SUBJECT: AMENDMENT OF SOURCE MATERIALS LICENSE SUA-1350 TO REMEDIATE
CATCHMENT BASIN CONTAMINATION AT THE KENNECOTT URANIUM
COMPANY'S SWEETWATER PROJECT, AMENDMENT 21 (TAC LU0073)

TECHNICAL EVALUATION REPORT FOR
KENNECOTT URANIUM COMPANY'S CATCHMENT BASIN REMEDIATION PLAN
FOR THE SWEETWATER URANIUM PROJECT

DATE: May 9, 2005

FIGURE 1

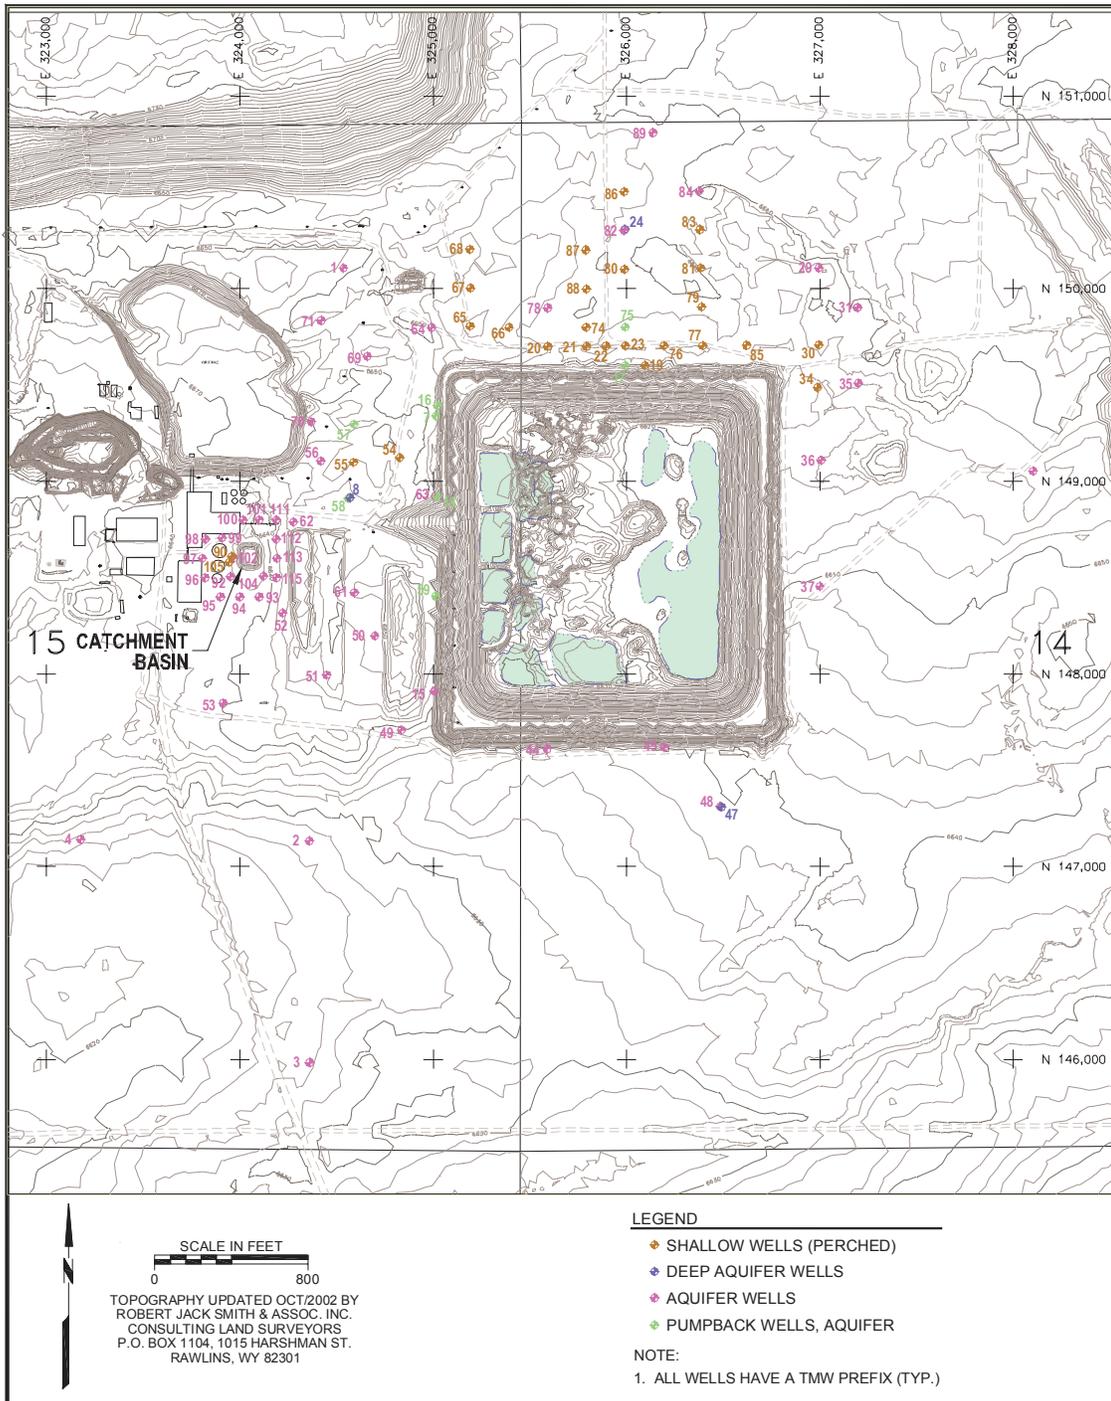
KUC's Sweetwater Uranium Project mill site is located in a remote area of south-central Wyoming, in Sweetwater County, approximately 42 miles northwest of Rawlins, Wyoming. The Sweetwater Uranium Project (Site), as defined by the NRC-licensed area, occupies approximately 445 ha (1,100 ac) and consists of a mill, ancillary buildings, existing tailings impoundment, and the area of proposed impoundments, evaporation ponds, and diversion channels. Bordering the Site is an overburden soil pile and a uranium ore pit (see Figure 1).
